## MINOR AMENDMENT OF AN APPROVED PRELIMINARY PLAT

### EVALUATION FORM & DECISION

**Project Name:** Vuecrest Estates Preliminary Plat Amendment

**File Number:** LUA13-000642, Minor Amendment

LANDSCAPE PLAN - (VUECREST II SHORT PLAT)  
SCALE 1"=20'

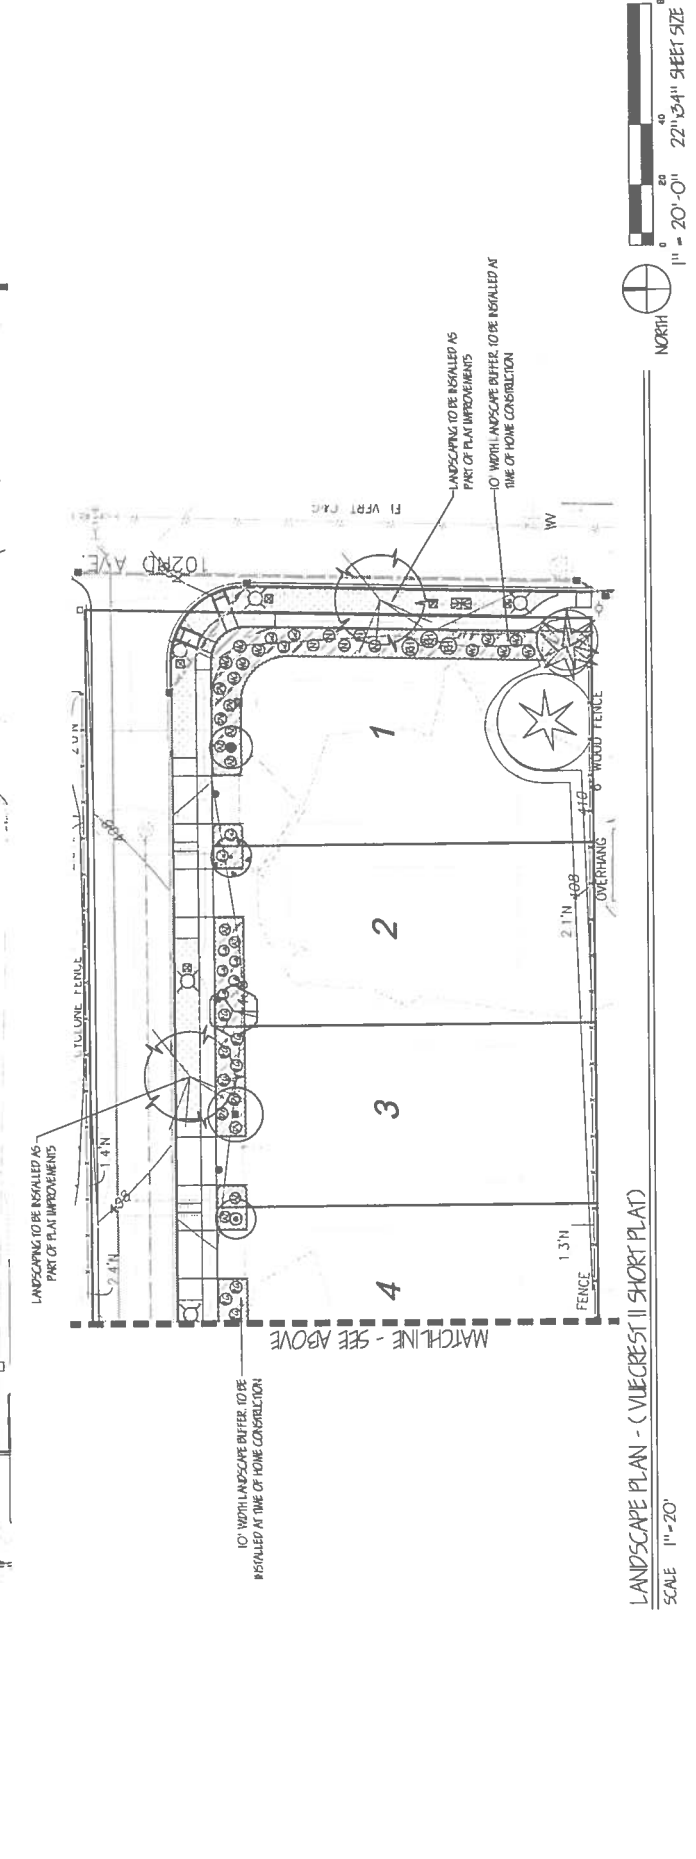
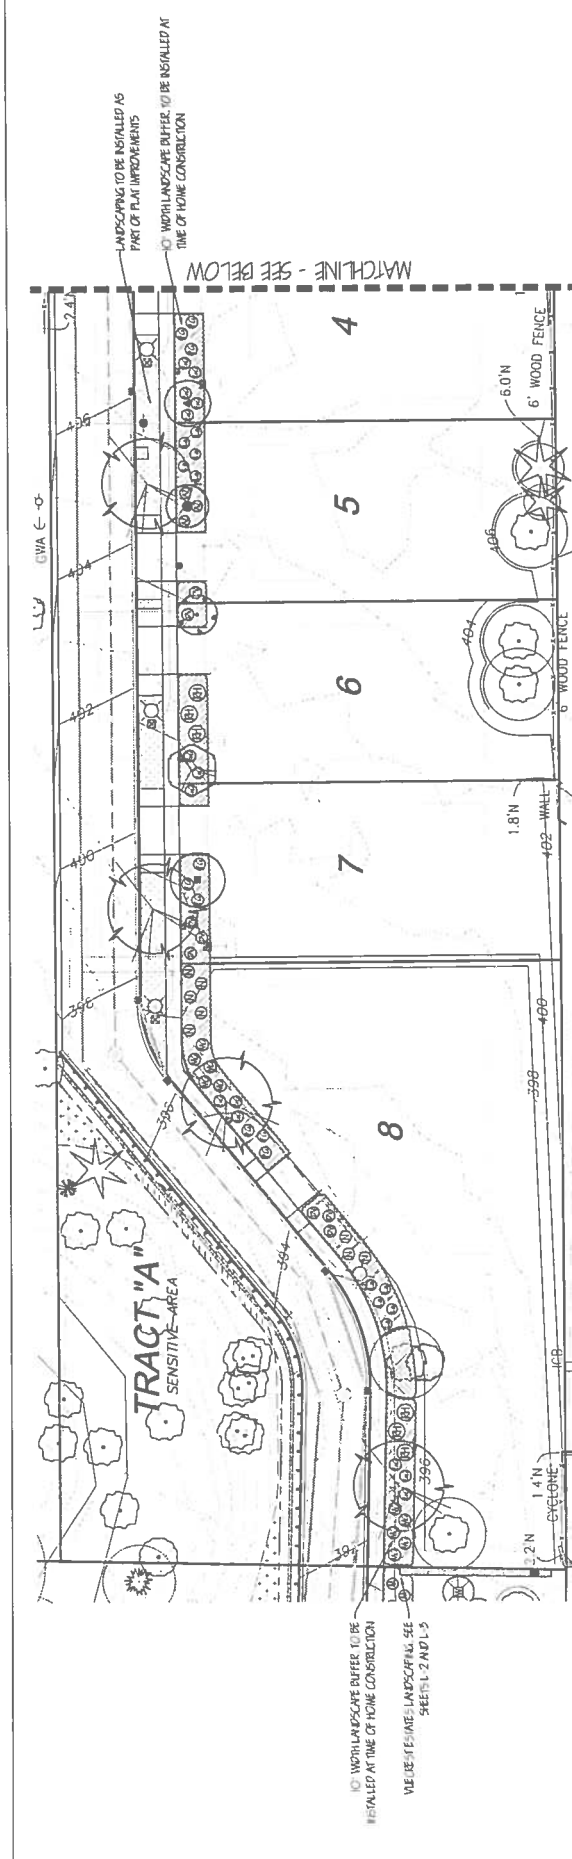
<p><i>retained. The project proposal indicates that 44 trees would be retained (Exhibit 3). Therefore, 15.1 two-inch diameter trees, or 181.2 "replacement inches" are required. Based on the submitted landscape plan, the applicant is proposing roughly 91 two-inch diameter trees or 182 caliper tree replacement inches which would satisfy the 30% tree retention requirement. Staff would favor the preservation of existing trees over replacement trees as part of compliance with this development standard.</i></p> <p><i>During construction, trees required to be retained (i.e., protected trees) would be required to erect and maintain a six-foot-high chain link temporary construction fence around the drip line of any tree to be retained.</i></p>
✓	<p><b>Parking:</b> Parking regulations require that a minimum of two parking spaces be provided for each detached dwelling.</p> <p>Driveway cuts are required to be a minimum of five (5) feet from property lines and new driveways may be a maximum of 16 feet in width at the property line. Maximum driveway slopes shall not exceed fifteen percent (15%), provided that driveways exceeding eight percent (8%) shall provide slotted drains at the lower end with positive drainage discharge to restrict runoff from entering the garage/residence or crossing any public sidewalk.</p> <p><u>Staff Comment:</u> <i>Sufficient area exists, on each lot, to accommodate off-street parking for a minimum of two (2) vehicles. This is typically achieved by providing a two (2) car garage for each single family home. Compliance with individual driveway requirements would be reviewed at the time of building permit review.</i></p>

2. The applicant shall meet the minimum tree retention requirement by retaining thirty percent (30%) of the healthy trees or as an alternative to retaining trees, plant the equivalent of 181 replacement trees inches on the site. A final tree retention plan and landscaping plan shall be submitted to and approved by the City of Renton Project Manager prior to issuance of a construction permit.
